Re: BusConnects Belfield/Blackrock to City Centre Core Bus Corridor Scheme
Co. Dublin

RE: BusConnects Belfield/Blackrock to City Centre Core Bus Corridor Scheme

Ref: Case reference: HA29N.313509

Waterloo Road View of 1-11 Pembroke Road

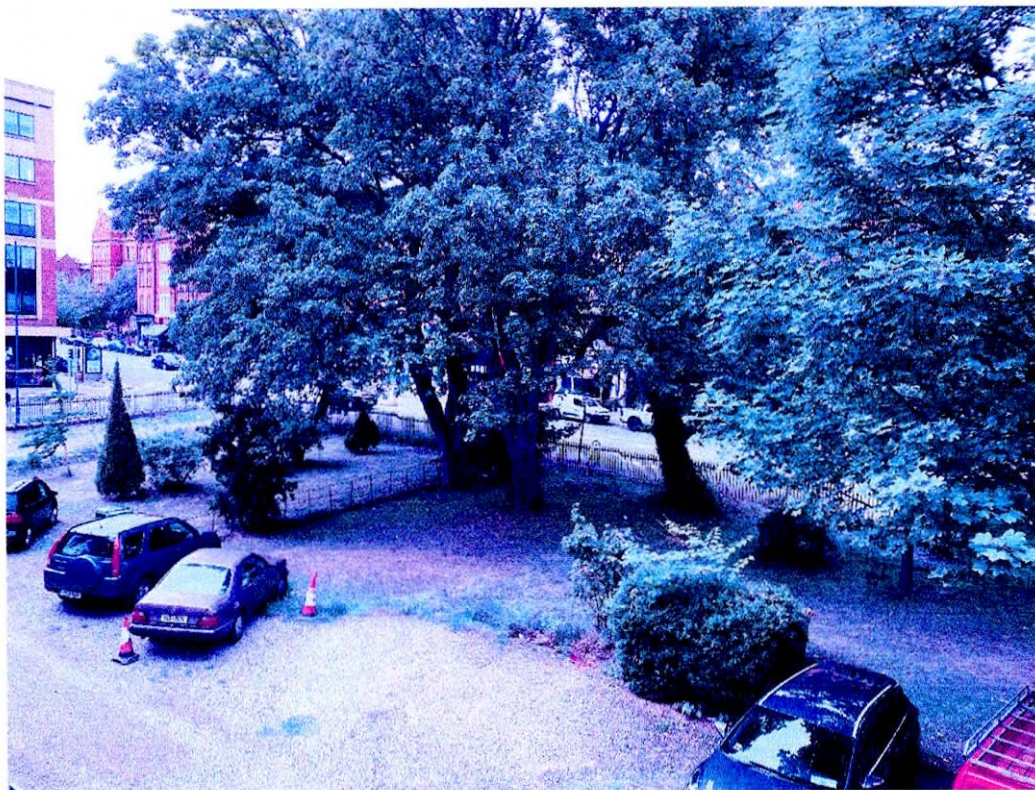
-cast iron railings, granite plinth, side gate (proposal to widen to vehicular traffic unacceptable)

Pembroke Road view of Nos 1-11 Pembroke Road terrace with parkland gardens, mature trees

-proposal to create access control to left side gateway and close up right side gateway

View of parkland garden from No.9

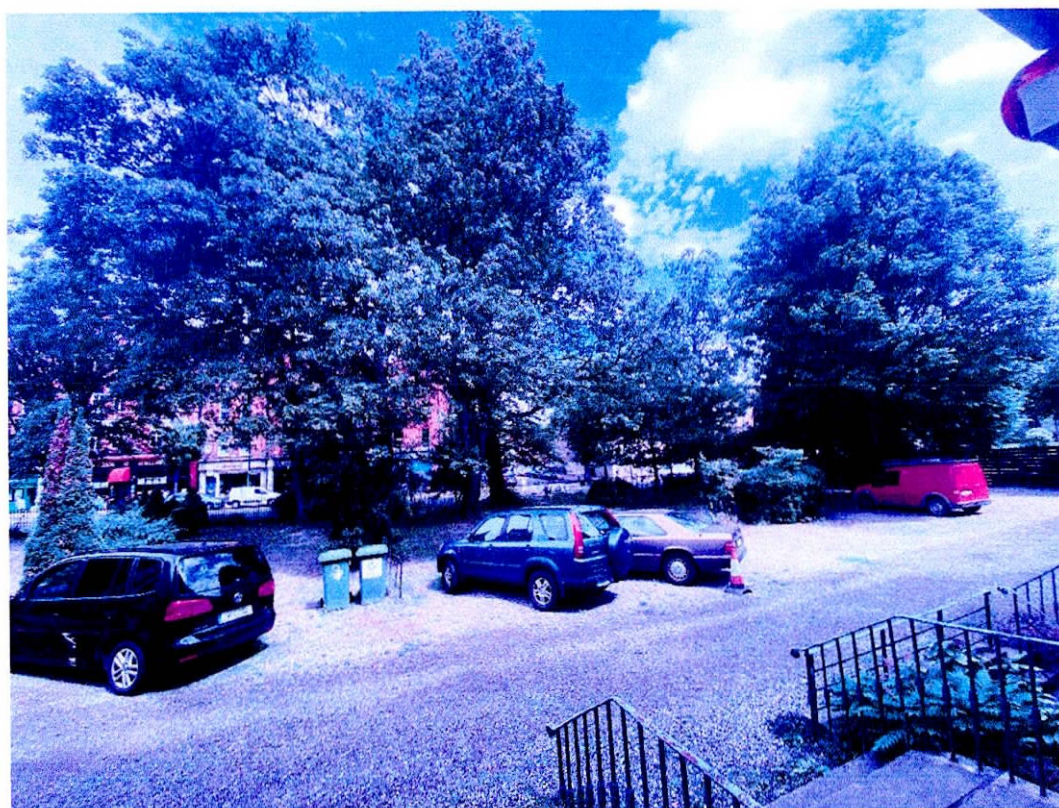
- dense tree cover apparent to entire gardens

View of parkland garden from No.3 Pembroke Road

-tree canopy and root zone extends across entire gardens
